LTR-NRC-19-36

Subject: Transmittal of Responses to the NRC Request for Additional Information for WCAP-18240-P, "Westinghouse Thermal Design Procedure (WTDP)" (Proprietary / Non-Proprietary)

**Responses to the Request for Additional Information for WCAP-18240-NP,  
“Westinghouse Thermal Design Procedure (WTDP)”  
(Non-Proprietary)**

## Response to Request for Additional Information (RAI) on WCAP-18240-P, “Westinghouse Thermal Design Procedure”

Figure R-2 – Comparison of  $DNBR_i$  Distributions from the Sensitivity Study

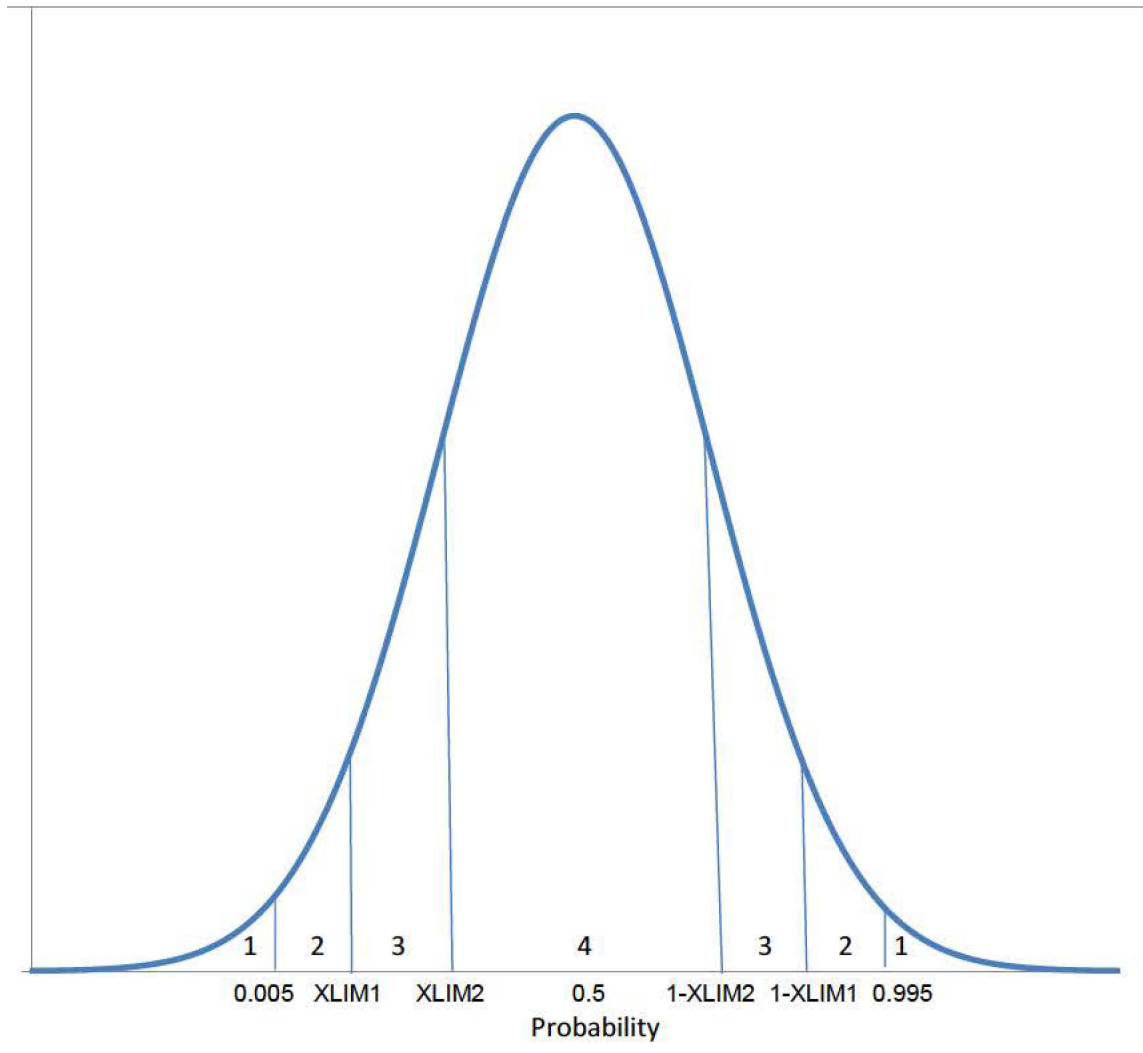
*Westinghouse's current method for determining the DNBR sensitivity is to use a [*

*] <sup>a,c</sup>*

A method sensitivity study was performed by selecting 50 cases [ <sup>a,c</sup> where the  $\text{DNBR}_i$  values were greater than the 95/95 DNBR limit. In each case, additional DNBR calculations were performed to determine the 95/95 DNBR sensitivity based on about 5000  $\Delta\text{DNBR}$  values from sampling of the parameter uncertainties. The standard deviations of the uncertainties were the same as those in the original calculations in Table A-1, except for some parameters [

<sup>a,c</sup> The resultant 95/95 DNBR values of the sensitivity cases are listed in Table R-2 for comparison with the original values. A comparison of the  $\text{DNBR}_i$  distributions is shown in Figure R-2.

The comparison shows similar  $\text{DNBR}_i$  distributions between the 95/95  $\Delta\text{DNBR}$  sensitivity result and the result from the sample calculation in Attachment A. [
